Subject: AP1000 COL Standard Technical Report Submittal of APP-GW-GLR-117, Revision 1 (TR 117)

APP-GW-GLR-117, Revision 1

“Incorporation of the Maintenance Rule”

APP-GW-GLR-117
Revision 1

Figure 17.4-1

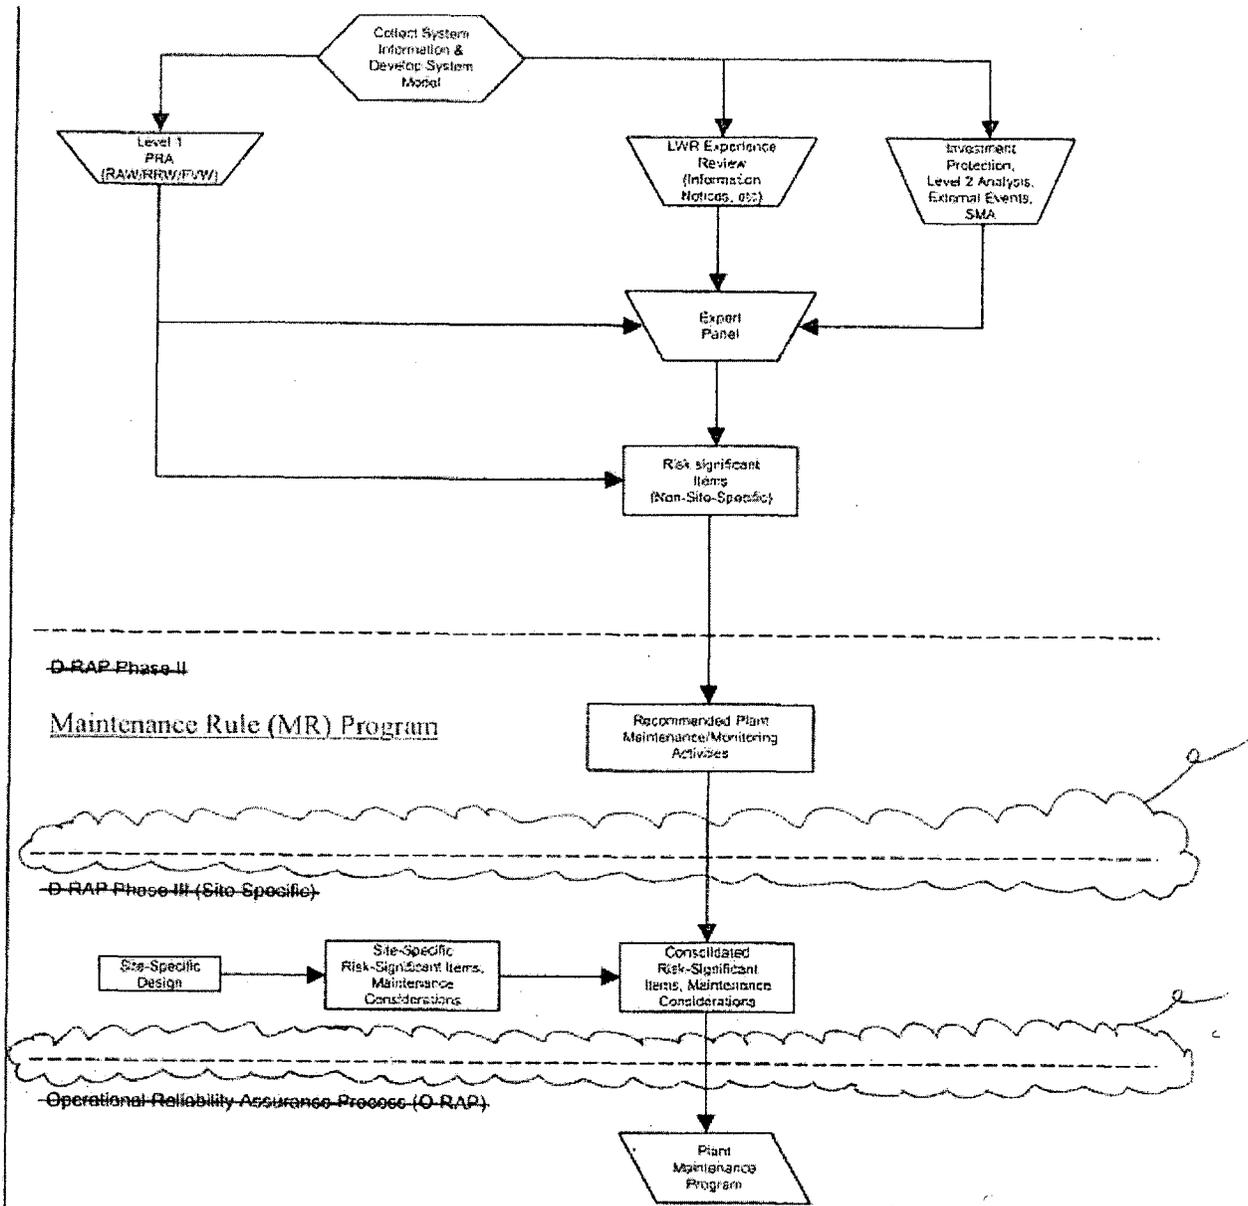
The D-RAP, ~~as shown in Figure 17.4-1, is implemented during in three phases. The first phase, the Design Certification phase, defines the overall structure of the AP1000 D-RAP, and implements those aspects of the program which are applicable to the design process. During this phase, The D-RAP identifies risk-significant SSCs are identified for inclusion in the Maintenance Rule (MR) Program (Reference 10) using probabilistic, deterministic, and other methods.~~

~~Finally, Figure 17.4-1 shows The MR Program-Operational Reliability Assurance Process~~

~~(O-RAP). This phase, which is implemented by the Combined License applicant, provides confidence that the operations and maintenance activities performed by the operating plant support should maintain the reliability assumptions made in the plant PRA.~~

~~During Phase II of the D-RAP, maintenance assessments and recommendations are developed to enhance the reliability of the plant risk significant components. These activities are shown in Figure 17.4-1 as "Recommended Plant Maintenance Monitoring Activities." The recommendations can take the form of monitoring activities or preventive, predictive or corrective maintenance, and are dependent upon the types of failure modes that a component may experience. These modes are generally determined by a failure modes, effects and criticality analysis. The maintenance recommendations address the most significant failure modes of the component.~~

~~Site specific activities of the D-RAP are the responsibility of the Combined License applicant. Figure 17.4-1 shows these activities in the Phase III area of the figure. At this stage, the D-RAP package is modified or appended based on considerations specific to the site.~~

Figure 17.4-1

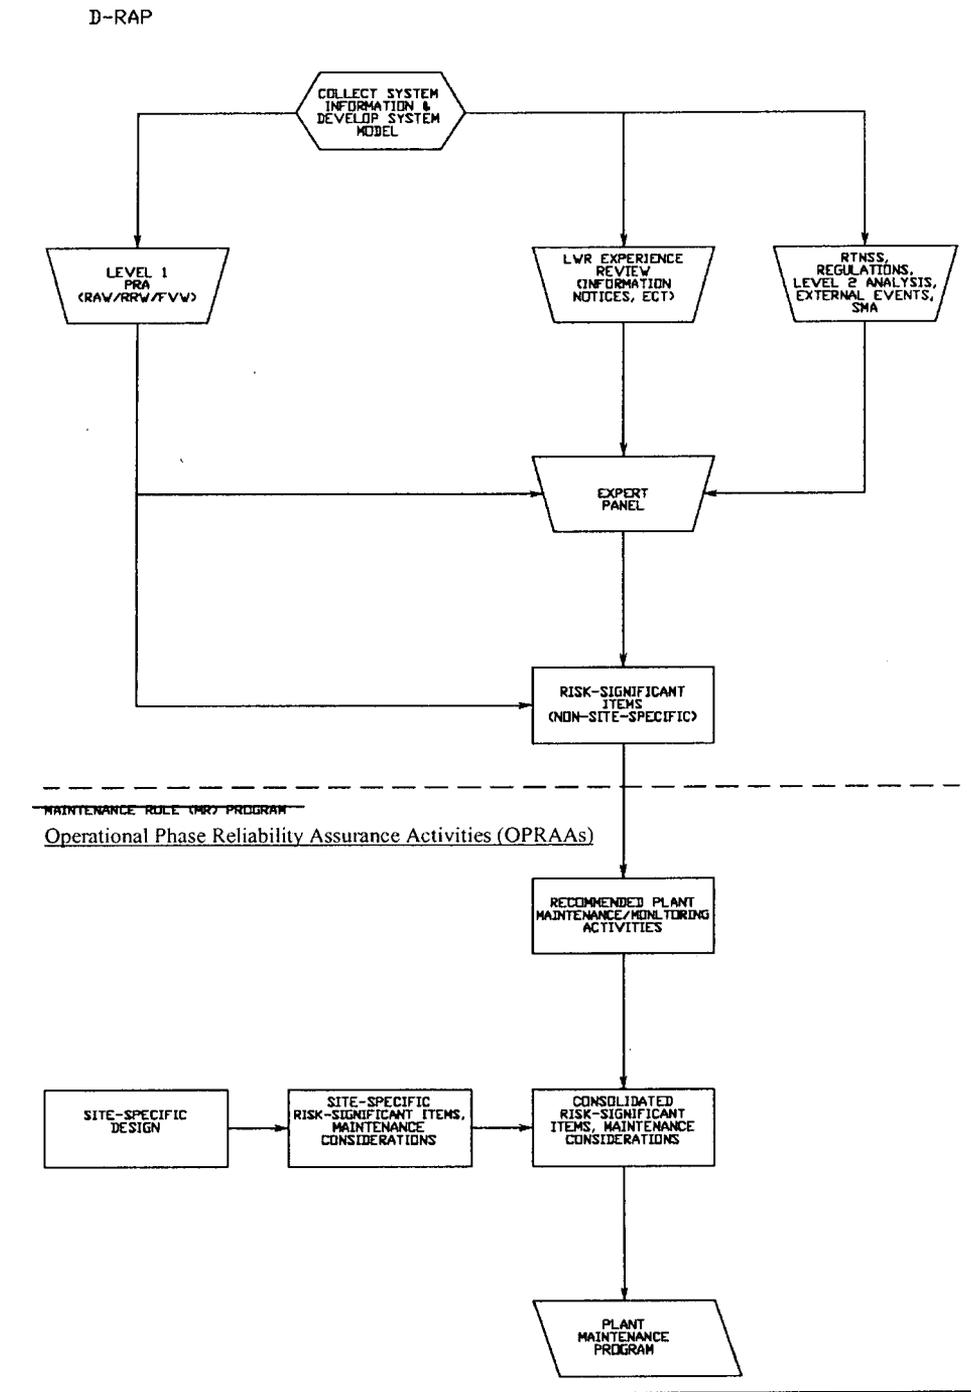
The D-RAP, shown in Figure 17.4-1, is implemented during Design Certification. The D-RAP identifies risk-significant SSCs for inclusion into the site Operational Phase Reliability Assurance Activities (OPRAAs) ~~Maintenance Rule (MR) Program (Reference 4)~~ using probabilistic, deterministic, and other methods.

The OPRAAs ~~MR Program~~ provides confidence that the operations and maintenance activities performed by the operating plant support should maintain the reliability assumptions made in the plant PRA.

Design Reliability Assurance Program and MR Program Operational Phase Reliability Assurance Activities
